REMARKS

00 P 7882 US

FIG. 1
(PRIOR ART)

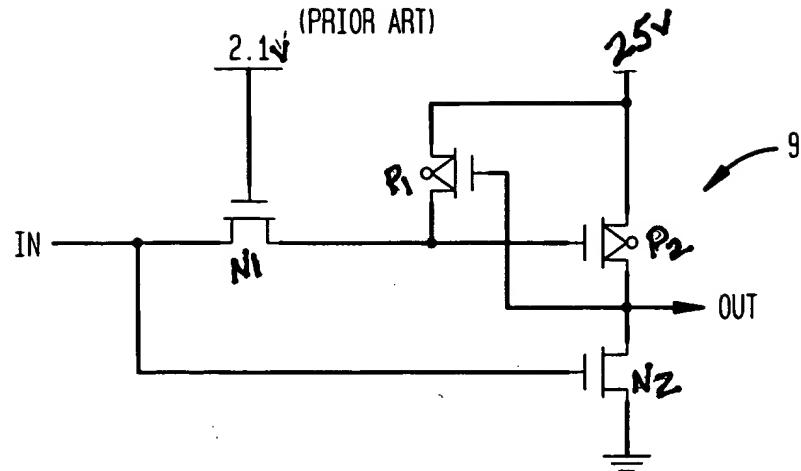
The drawings have been objected to because Figure 2 has a mislabeled transistor and is not consistent with the specification and claims. The drawing has been corrected. Claim 2 has also been amended to be more consistent with the illustration. This amendment does not narrow the claim. Figure 1 has also been amended to be more consistent with the specification. It is respectfully submitted that the drawings are in compliance with the rules.
